Remarks

This is in response to the second non-final Office Action mailed February 22, 2005.

Amendments to the Drawings

FIG. 22

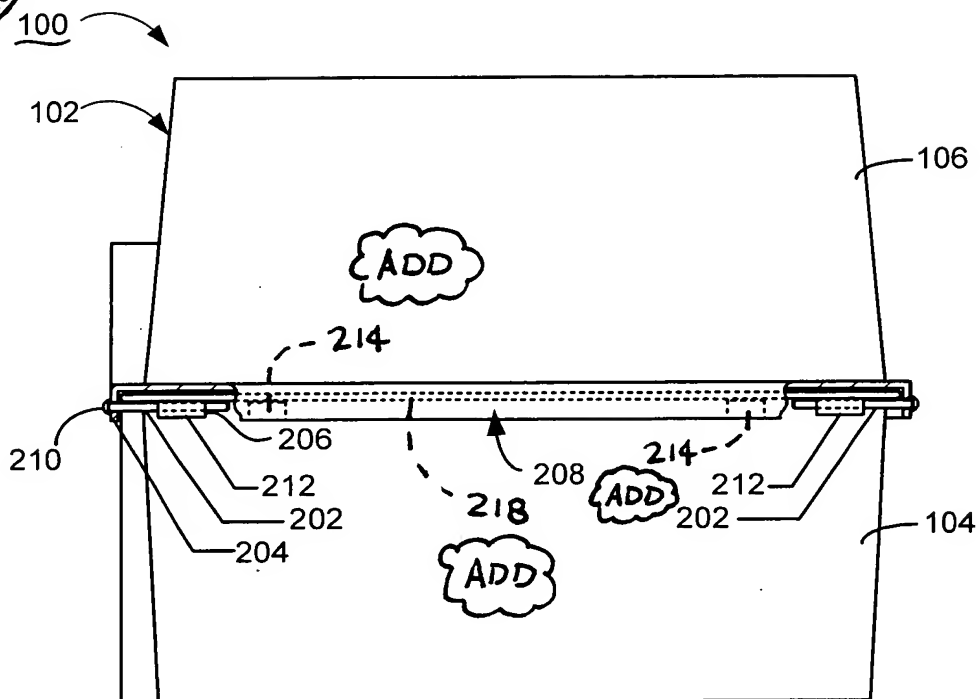
The amendments above are accordingly directed to the drawings, specification and claims. The drawings have been amended to add reference numerals 214, 216 and 218 to FIGS. 22 and 23 to numerically identify various latching features shown therein when the case was originally filed.

The attached sheet of drawings includes changes to FIGS. 22 and 23. This sheet, which includes the addition of reference numerals 214, 216 and 218 to FIGS. 22 and 23 replaces the original drawing sheet 11/11.
